REQUEST

Current Zoning: NC (neighborhood center)
Proposed Zoning: MUDD-O (mixed use development, optional)

Approximately 0.94 acres located at the southeast intersection of Commonwealth Avenue and The Plaza, north of East Independence Boulevard.

STAFF RECOMMENDATION

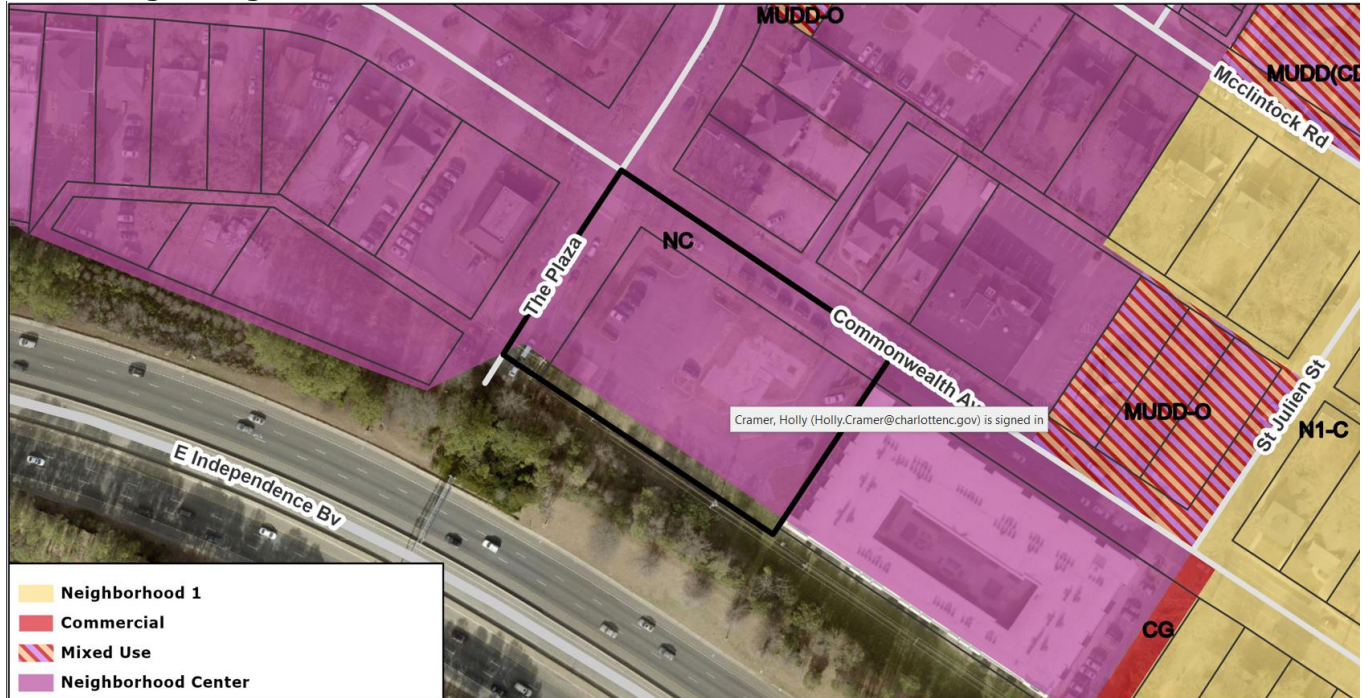
1. Show required right-of-way trees.

2. The back of curb sidewalk shown is not acceptable to CDOT, remove from plan. Based on the context of the street CDOT can consider a local office/commercial wide with parallel parking and curb bumpouts per CLDSM U-05, with amenity zone instead of planting strip. In addition, remove proposed park – park not allowed in right-of-way.
